**Town of Surfside
SPECIAL PLANNING & ZONING BOARD
AGENDA**

February 11, 2021 – 6:00 p.m.

To: Planning and Zoning Board
Thru: Andrew Hyatt, Town Manager
From: Walter Keller, PE, AICP., Town Consultant Planner
Marlin Engineering, Inc.
CC: Jason Greene, Assistant Town Manager
Lillian Arango, Town Attorney
Date February 1, 2021
RE: 9133 – 9149 Collins Avenue – Seaway Condo Acquisition LLC – Site Plan Amendment

SHEET NO. **A3.00**

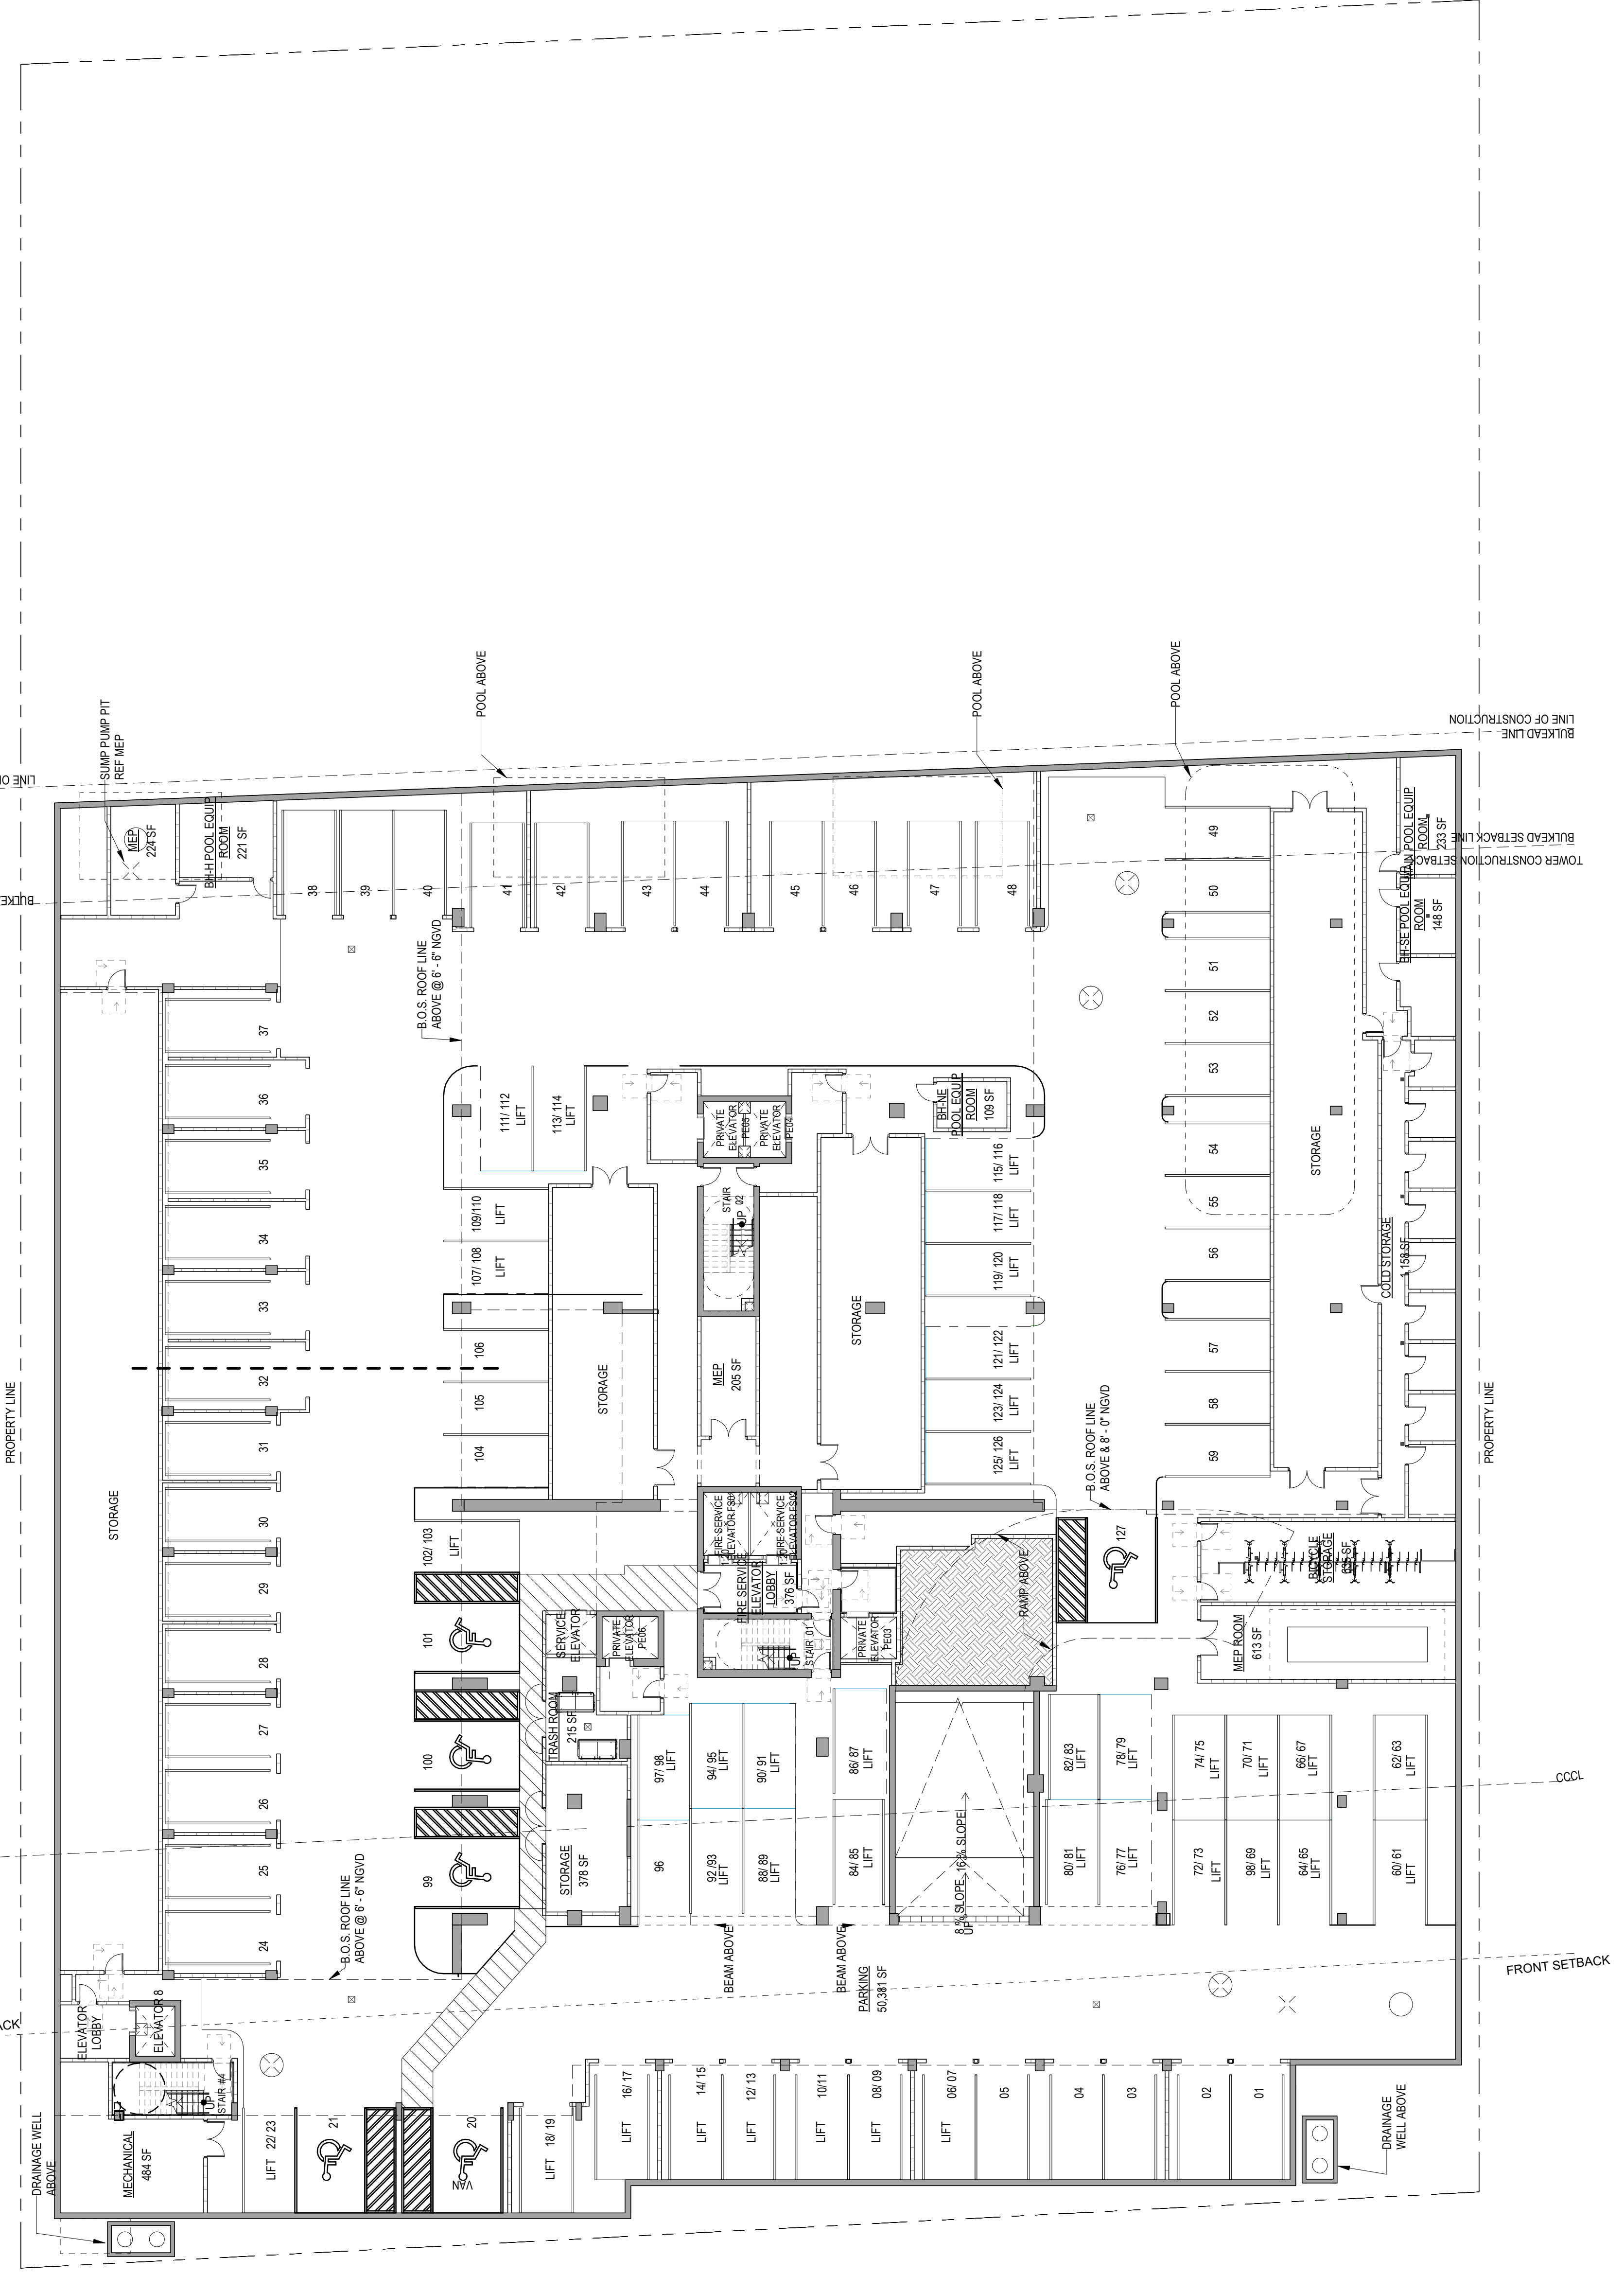
As shown on Amended Sheet A3.00, Applicant proposes a larger underground parking garage, increasing the area from 36,250 square feet to 58,242 square feet. The Prior Approval included a significant number of car lifts to achieve the parking counts required by the Town Code. To accommodate market changes and consumer demand, including a desire to self-park as a result of the Covid-19 pandemic, Applicant proposes to minimize the car lifts and expand the underground garage footprint to accommodate more traditional methods of parking while maintaining the same amount of parking spaces as the Prior Approval (127 spaces). All proposed changes to the parking garage are underground and will not impact the Prior Approval’s above-grade landscaping, ingress/egress, or the historic Seaway building.
